THREE MILE ISLAND NUCLEAR STATION
UNIT NO. 1 EMERGENCY PLAN IMPLEMENTING PROCEDURE 1004.6
ADDITIONAL ASSISTANCE AND NOTIFICATION

Three Mile Island Nuclear Station Temporary Change Notice (TCN)

1. Procedure 1004.29 3 Activation of the O.S.C.
No Present Rev. No Title

THREE MILE ISLAND NUCLEAR STATION
UNIT NO. 1 EMERGENCY IMPLEMENTING PROCEDURE 1004.29
ACTIVATION OF THE OPERATIONS SUPPORT CENTER

OSC FLOOR PLAN

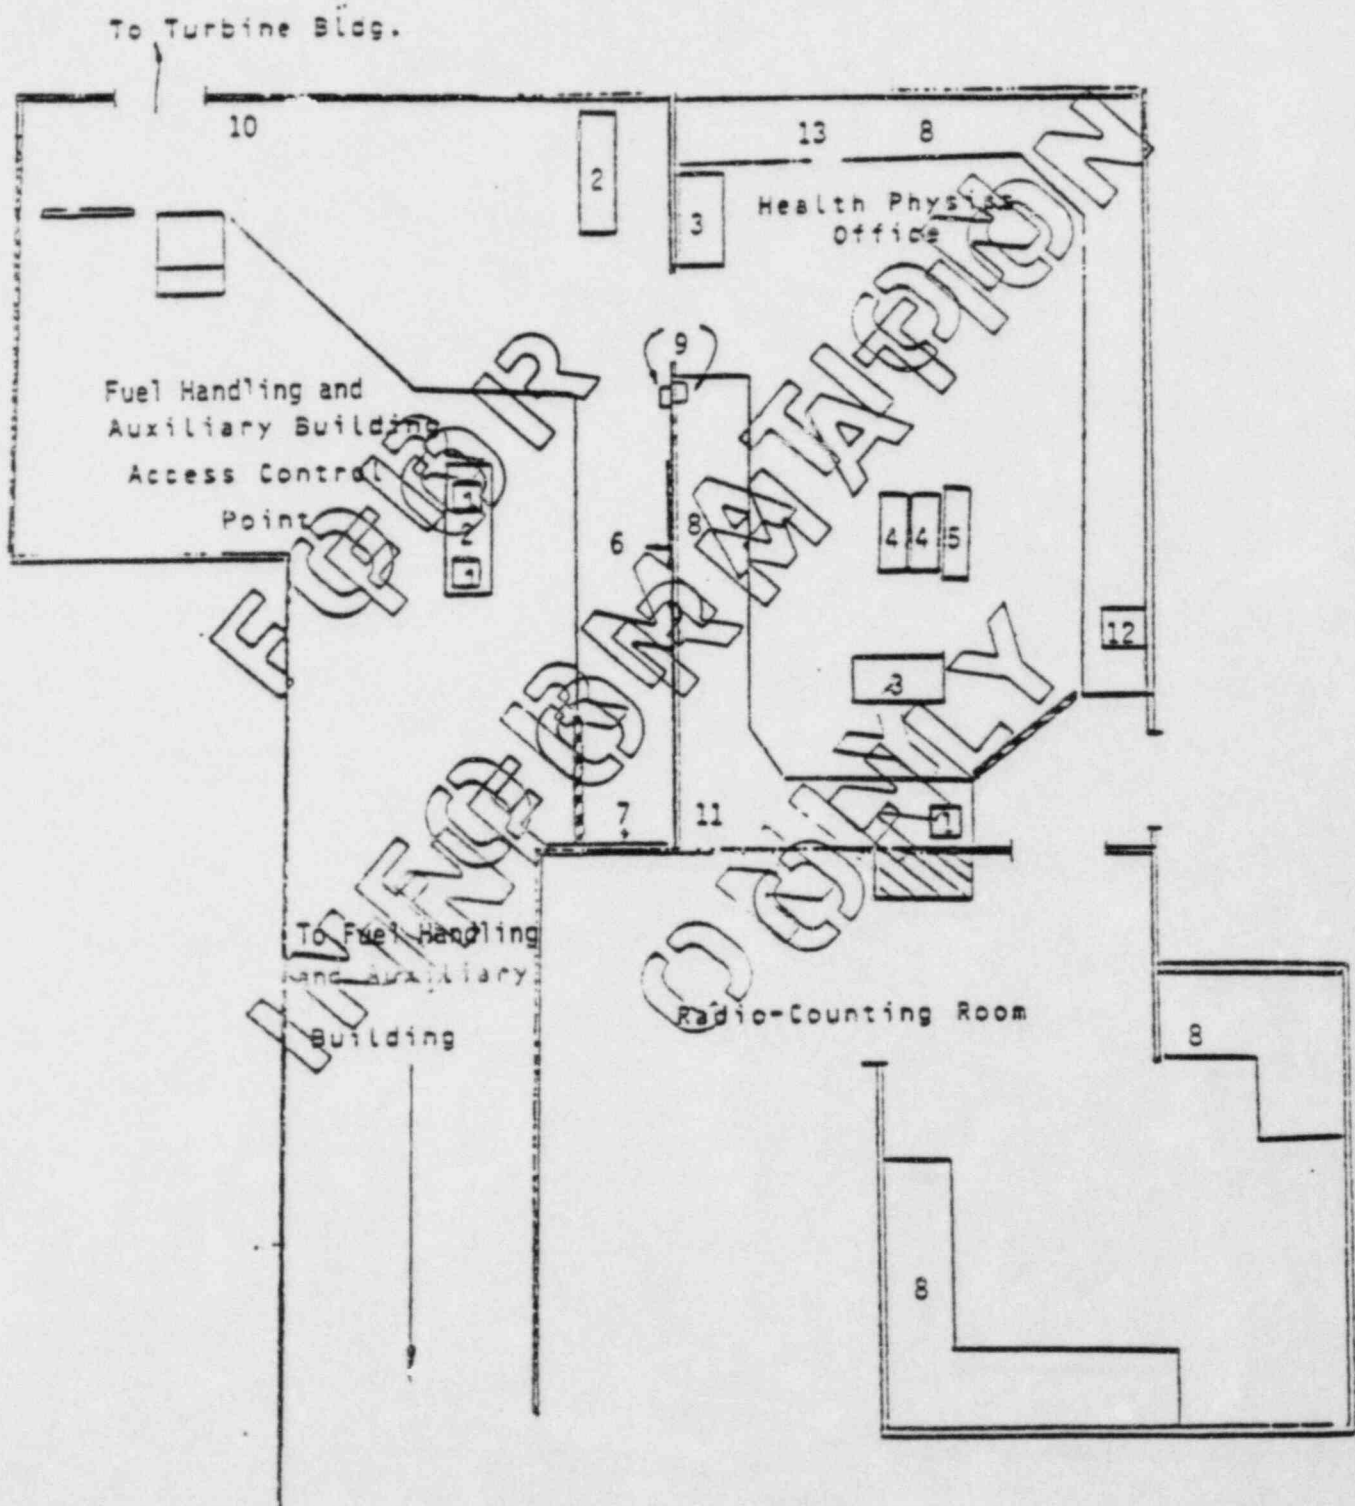
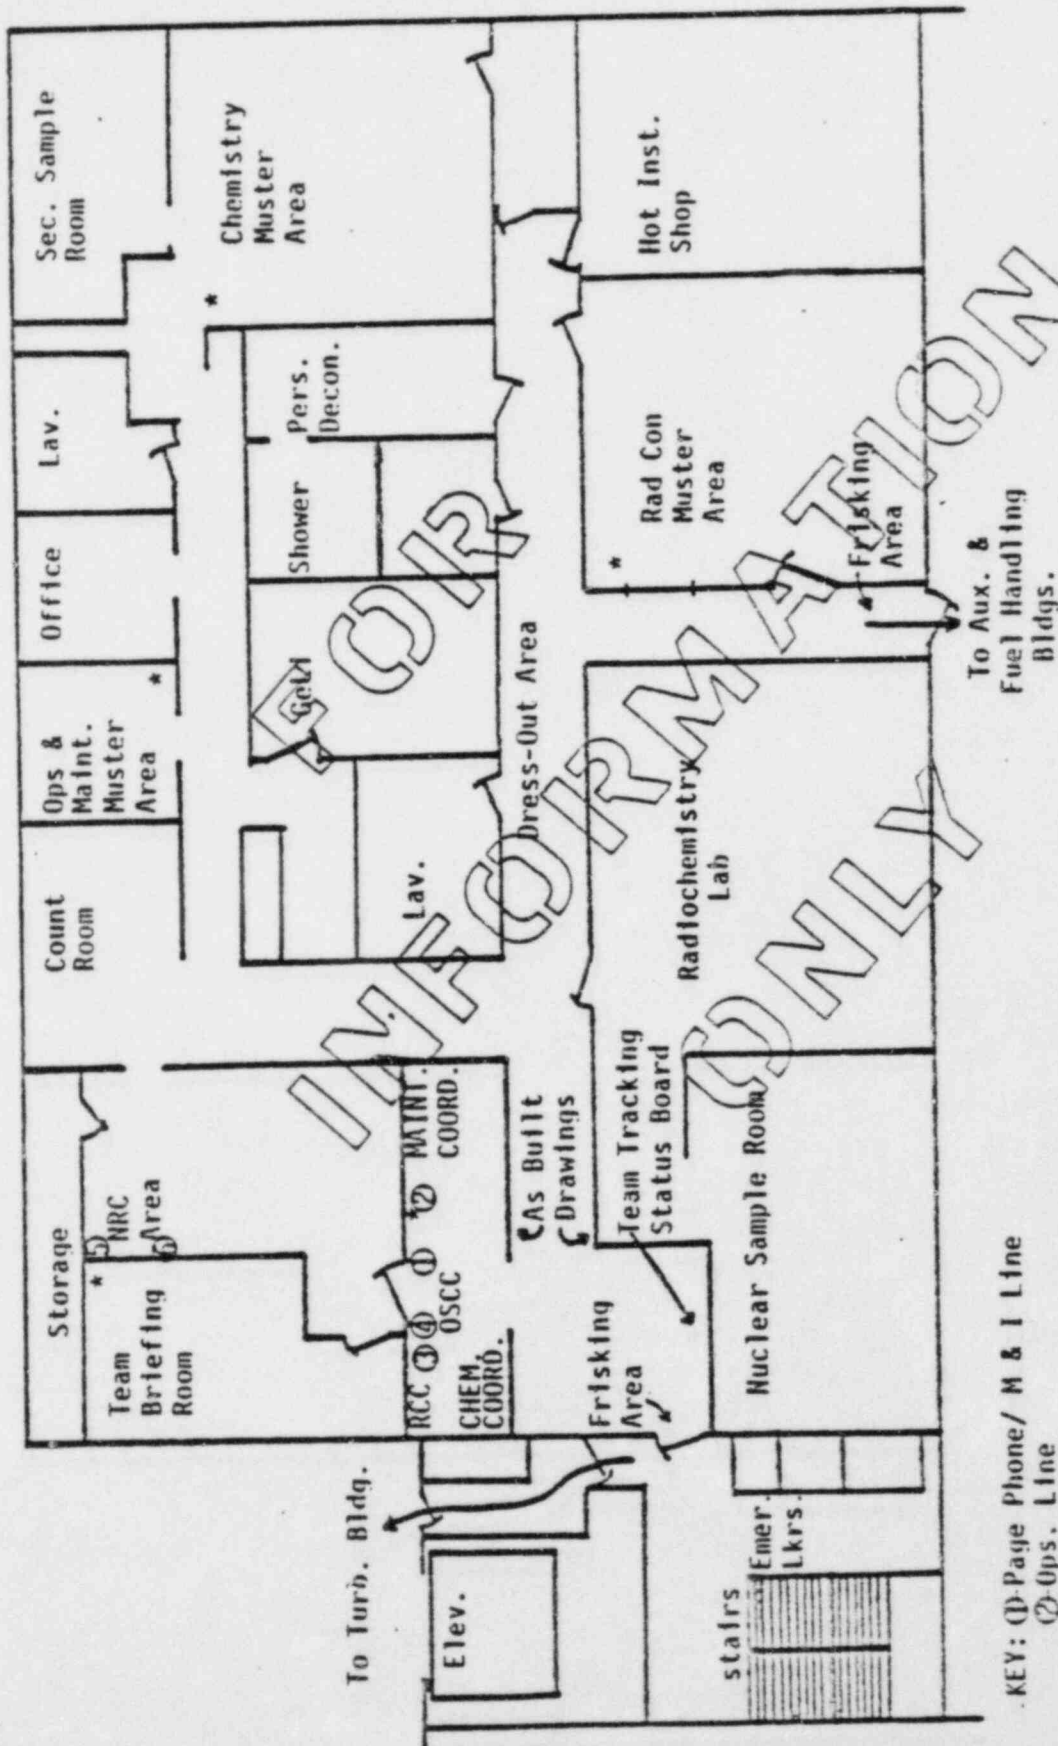
Update procedure to reflect new layout and method of operation.

NRC recommendations and periodic review

4.1.10 When all coordinator positions are filled with Onsite Duty Roster personnel, establish operations of the OSC ~~per the floor plan in Att I~~ and direct excess personnel to the established areas on Att I.
